COA (SP) 2024-004
DECEMBER 19, 2024

**STAFF REPORT
SPECIAL CERTIFICATE OF APPROPRIATENESS
FOR THE PROPERTY AT
3800 GRANADA BOULEVARD
A LOCAL HISTORIC LANDMARK**

Figure 4: North facade, 2019

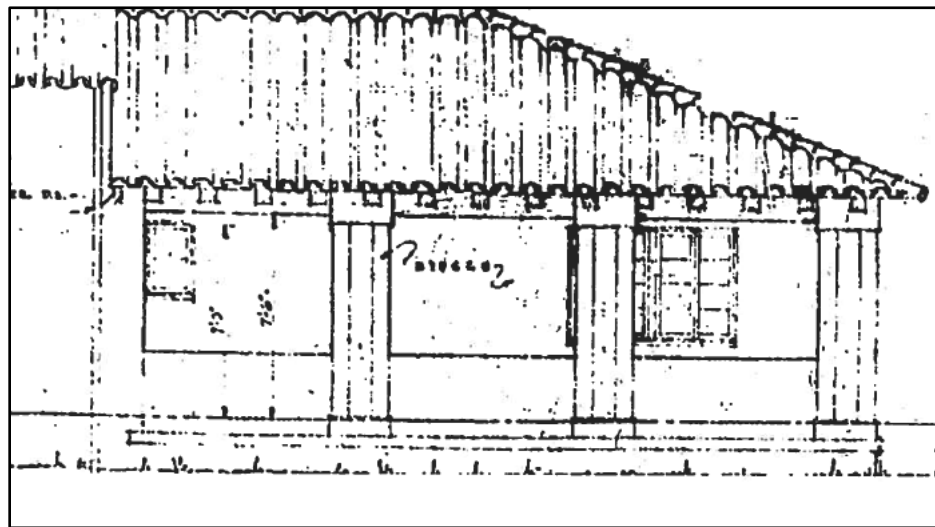
The proposed north elevation consists of the existing, historic residence to the east and new construction to the west. The series of doors in the one-story eastern end of this façade was originally a screened service passage with a cypress beam, brackets, and cypress posts. It was enclosed at some point, retaining the cypress beam and the five openings, but inserting new

columns. The existing elevation drawings does not show the existing beam. See Figure 4. The proposal shows brackets, but no details are provided. Note the proportions of this section of the elevation is inconsistent with the extant home.

13. The “metal” roofs at the semi-circular connector to the “Storage” room and the rear covered terrace are to be copper.
14. The cypress beam at the north elevation is to remain and details are to be provided about the proposed brackets, columns, and how the doors are to be installed.
